<b>Title-Sujet</b> Rogers Pass Washroom Building, Parking Lot and Day Use Area Development – Glacier National Park		
<b>Solicitation No. - No. de l'invitation</b> 5P420-18-0499/A	<b>Date:</b> January 31, 2019	
<b>GETS Reference No. – No de reference de SEAG</b> PW-19-00859731	<b>Amendment No. - N° de la modif.</b> 001	
<b>Solicitation Closes:</b>		
<b>at – á</b> 02:00 PM	<b>on – le</b> February 20, 2019	<b>Time Zone - Fuseau horaire</b> MST - HNR
<b>F.O.B. - F.A.B.</b>		
<b>Plant-Usine:</b> <input type="checkbox"/>	<b>Destination:</b> <input checked="" type="checkbox"/>	<b>Other-Autre:</b> <input type="checkbox"/>
<b>Address Inquiries to: - Adresser toute demande de renseignements à :</b>		
Jen Maheu <a href="mailto:jennifer.maheu@canada.ca">jennifer.maheu@canada.ca</a>		
<b>Telephone No. - No de téléphone</b>	<b>Fax No. – No de FAX:</b>

**AMENDMENT 01**

This amendment is being raised to extend the solicitation closing date, distribute questions and answers from the bidders' conference on January 22, 2019 as well as other questions submitted, make changes to Appendix 1 – Combined Price Form, change BA 06 Construction Time and make changes to the tender package.

Figure 1 – Example of Traffic Ponding Considerations at Rogers Pass

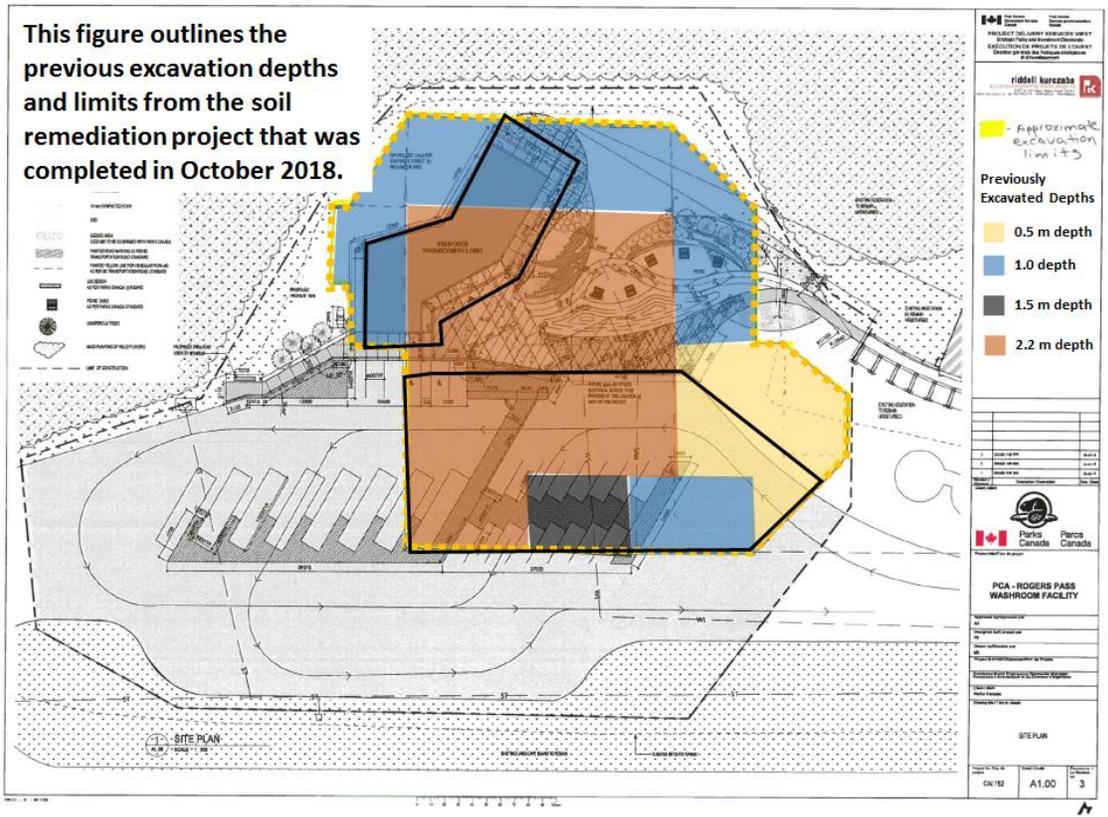
**Q8 Will the frontage road need to be open to Parks Canada and the public over the course of construction?**

A8 The Contractor will assume that they will have full control of the defined project limits over the course of construction, except from Nov 1, 2019, to May 15, 2020, the frontage road needs to be utilized by Parks Canada for avalanche control purposes, as is shown in Figure 1. During this time Parks Canada will operate and maintain the frontage roadway. The Contractor may continue with access to the remainder of the site but must allow for the avalanche control operations not to be impeded.
